Access Compliance Report

Public Rights-of-Way

(Curb Ramps)

Intersection ID: 9092	Main Street: KALYNNE_ST	Cross Street: LAKEWOOD_AV	Location: E
ADA ID: DCD776C420ED	Ramp Type: Perp	Initial Pass/Fail: Fail	Overall Compliance: No
Severity Score: 37.5			
Codes/Mitigation Info/Possible Solution		Field Measurements/Component Compliance

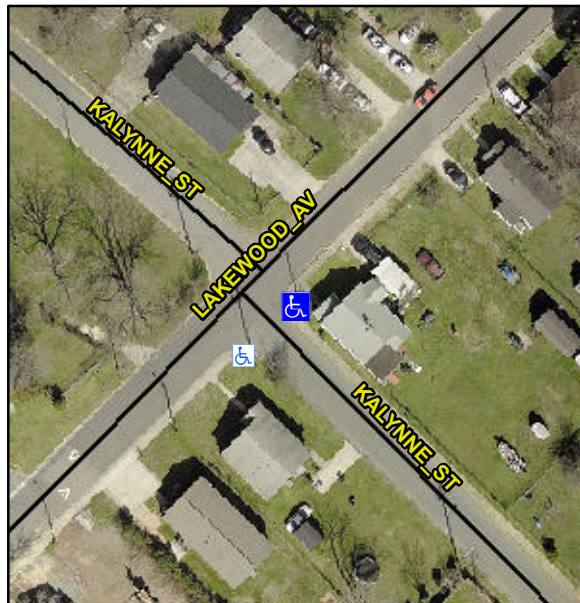
Not Found, R304.2.2, R304.5.3

Compliance	Description	Data	Compliance	Description	Data
N/A	Ramp Length (in)	38.0	No	Ramp Slope (%)	11.1
Yes	Ramp Width (in)	64.0	No	Ramp XSlope (%)	9.4
N/A	Flare Type LT	N/A	N/A	Flare Type RT	N/A
N/A	Flare Slope LT (%)	N/A	N/A	Flare Slope RT (%)	N/A
N/A	Flare Traversable LT?	N/A	N/A	Flare Traversable RT?	N/A
N/A	Landing Length (in)	N/A	N/A	DWS Provided?	N/A
N/A	Landing Width (in)	N/A	N/A	DWS Contrast?	N/A
N/A	Landing Slope (%)	N/A	N/A	DWS Length (in)	N/A
N/A	Landing X Slope (%)	N/A	N/A	DWS Full Width?	N/A
N/A	Landing Curb? (Y/N)	N/A	N/A	DWS Offset (in)	N/A
N/A	Shared Landing?	N/A			
N/A	Gutter Ponding?	Yes	N/A	Gutter Slope (%)	N/A
N/A	Gutter Lip Ht (in)	N/A	N/A	Gutter X Slope (%)	N/A
N/A	Painted X Walk1?	No	N/A	Painted X Walk2?	N/A
	X Walk 1 Direction	To W		X Walk 2 Direction	N/A
N/A	X Walk 1 Width (in)	N/A	N/A	X Walk 2 Width (in)	N/A
	X Walk 1 Slope (%)	2.1		X Walk 2 Slope (%)	N/A
	X Walk 1 X Slope (%)	9.3		X Walk 2 X Slope (%)	N/A

Remove & Replace Entire Ramp.
